CAMBRIA AMD TASK FORCE  
PASSIVE TREATMENT SYSTEM EVALUATION

Prepared By:  
Jeffrey J. Westrick P.E., Rich Beam P.G., Max Scheeler  
May 30, 2008

PROJECT NO: AMD 56(2524)102.1

PROJECT NAME: KOONTZTOWN (OVEN RUN SITE "B")

## PIPING SCHEMATIC SAP #2

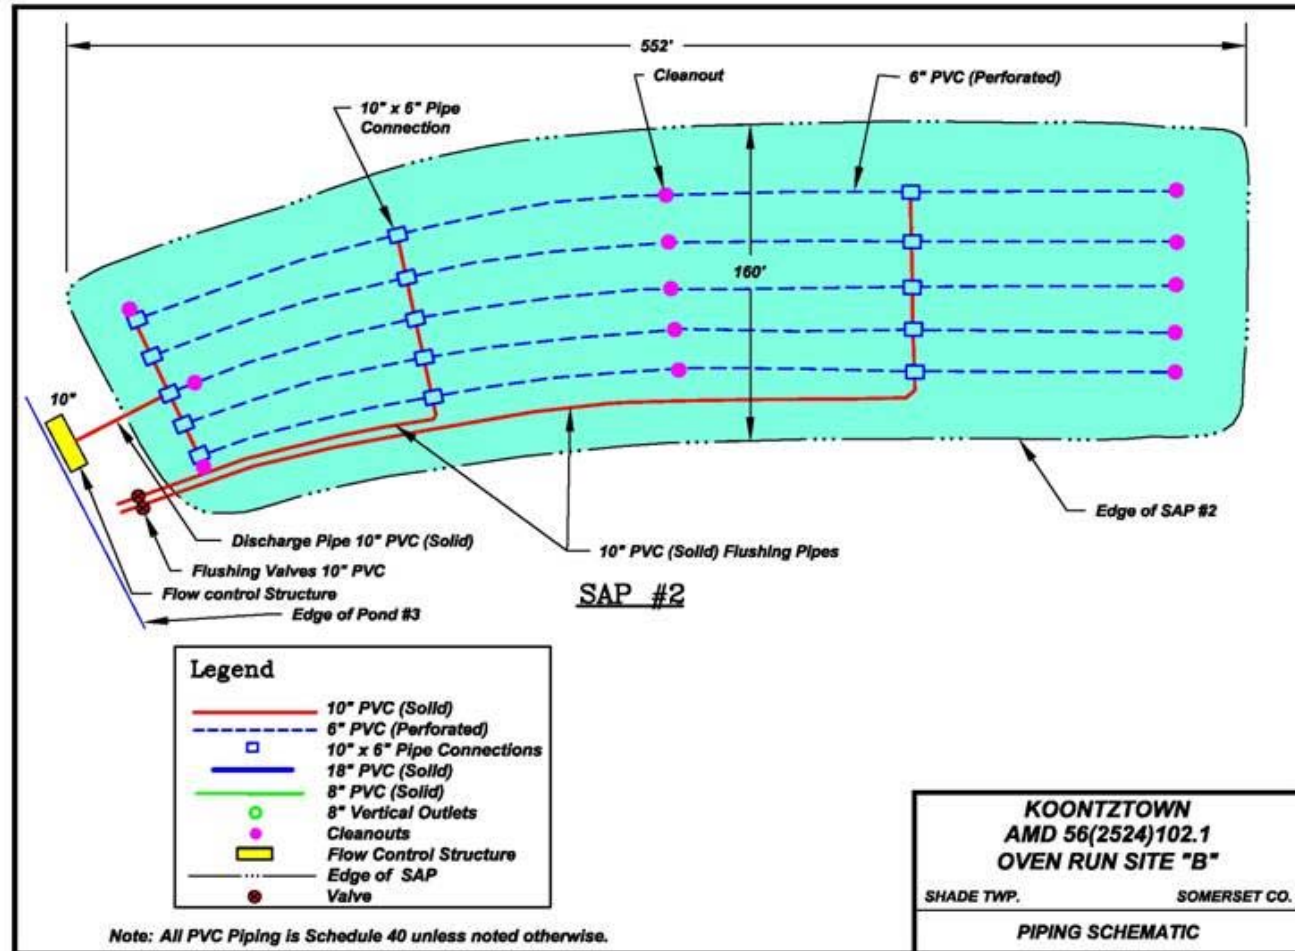
6. Broken cleanout on back end of SAP 2 allows short circuiting.
  7. Dewatering valve on Pond 3 is not functioning; thereby decreasing settling time for suspended solids in the flush water.

- Power clean all of the other SAPS pipes via the exposed cleanouts.
- Cut off all cleanouts just below the compost layer and install adapters and reinstall the existing screw caps – fix broken cleanout at back of SAP 2.

# SYSTEM FLOW RATES VS DESIGN FLOW RATE

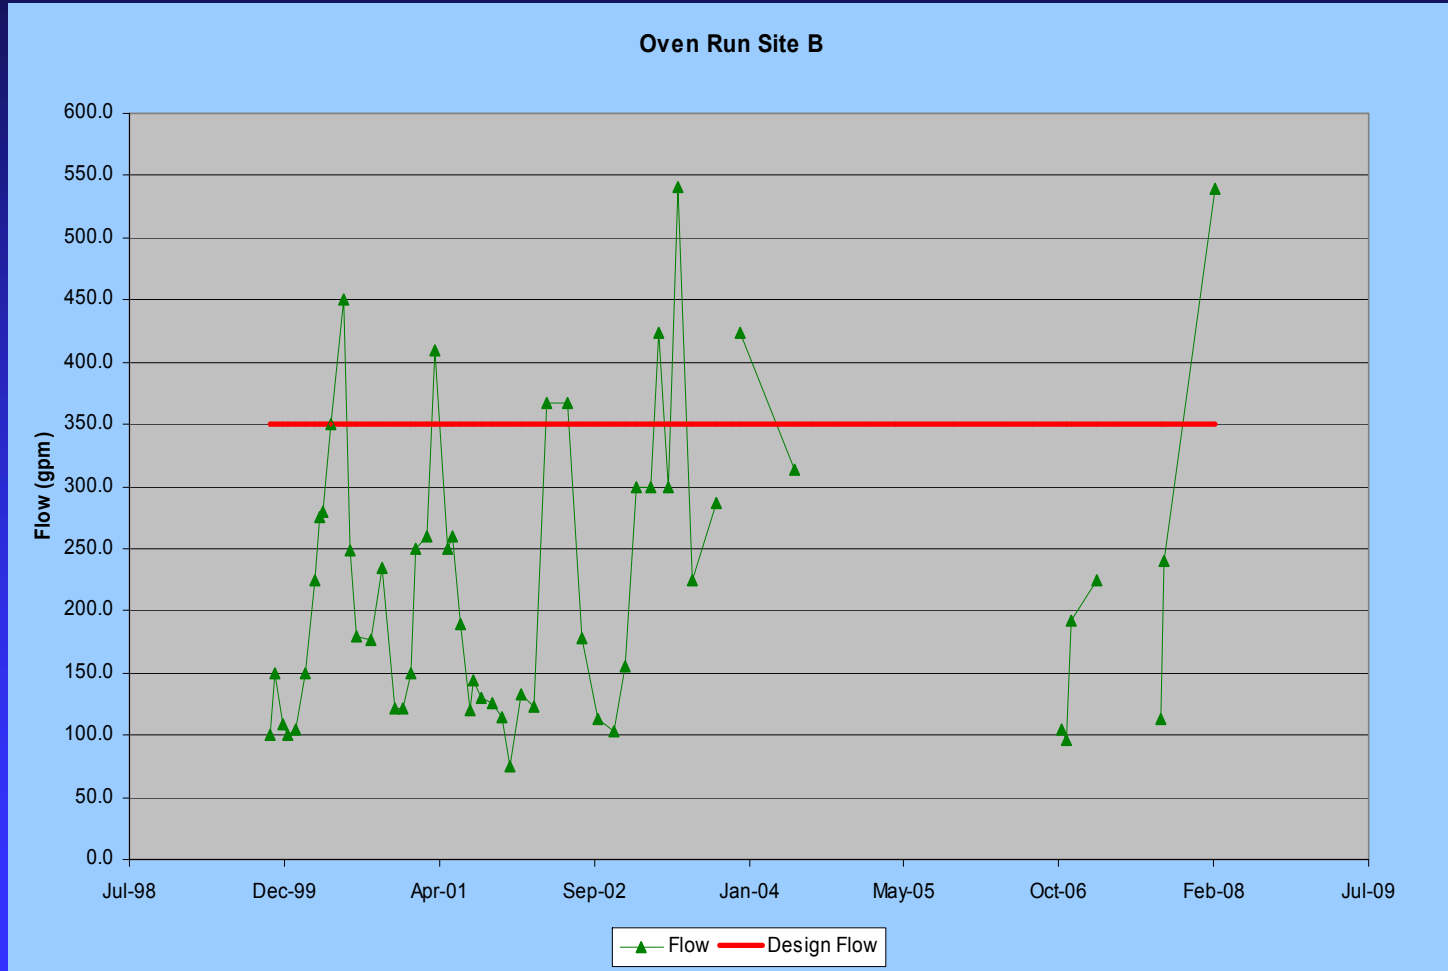
- Water Quality Trends and System Performance:
  1. Influent water quality has improved over time since the reclamation of Oven Run Site “C” (see Appendixes I through L).
  2. System performance decreased after March 2001 but has stabilized (see Appendixes M through P).
  3. System effluent pH ranges from 3.3 to 4.7.
  4. System still removing 200 to 300 mg/l of acidity; 30 to 40 mg/l of iron and 5 to 20 mg/l of aluminum.
  5. System flow rates periodically exceed design flow rates (see Appendix Q).

- Fluff the compost layer of SAP 1 and SAP 2 and replace compost in any areas as needed.
- Using the survey results, adjust the stop log elevations in the flow control boxes on the collection basin (Pond 1) to prevent overloading the treatment system beyond the designed flow rate of 350 gpm. The emergency spillway elevation should be three inches (3") higher than the primary discharge.

## PROPOSED BAFFLE LOCATION AND HEADER PIPE SEPARATION SAP #2

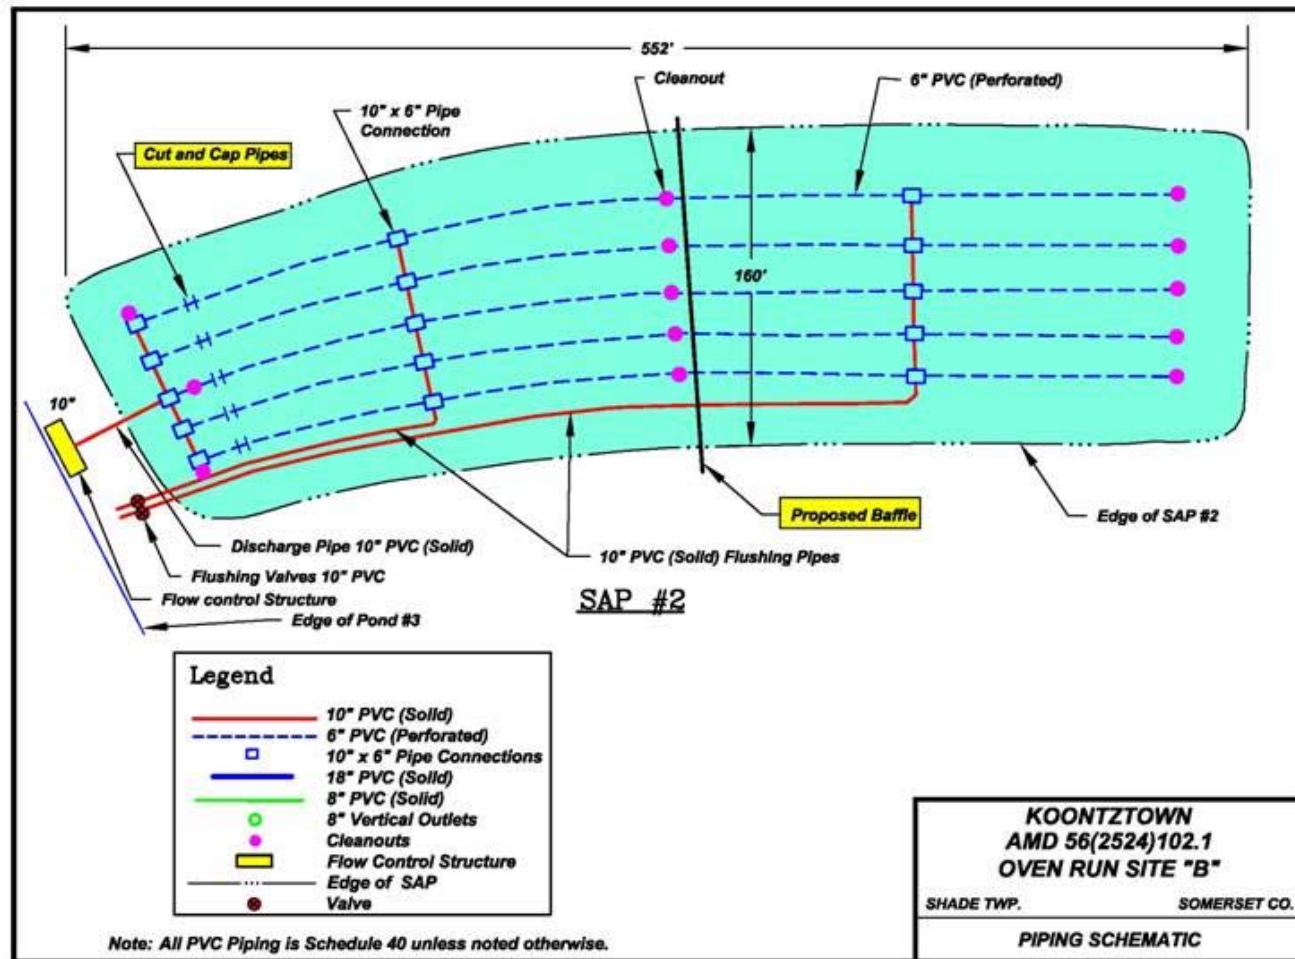
8. Flushing discharge rate on flush pipe #3 appears slower than #1 and #2.
  9. Flushing discharge rate on flush pipe #4 and # 5 appears fine; but broken cleanout on back end of SAP 2 allows short circuiting.

- Separate the SAP discharge header pipes from the perforated flushing pipes (by cutting and capping all of the six-inch (6") perforated pipes) to conform with current design practices for SAP systems to reduce preferential flow paths.

- Install two (2) plywood baffles on SAP 1 and one (1) plywood baffle on SAP 2 with tops of the baffles approximately one foot (1.0') below the top of embankment elevation. See Appendixes R and S for proposed baffle locations.
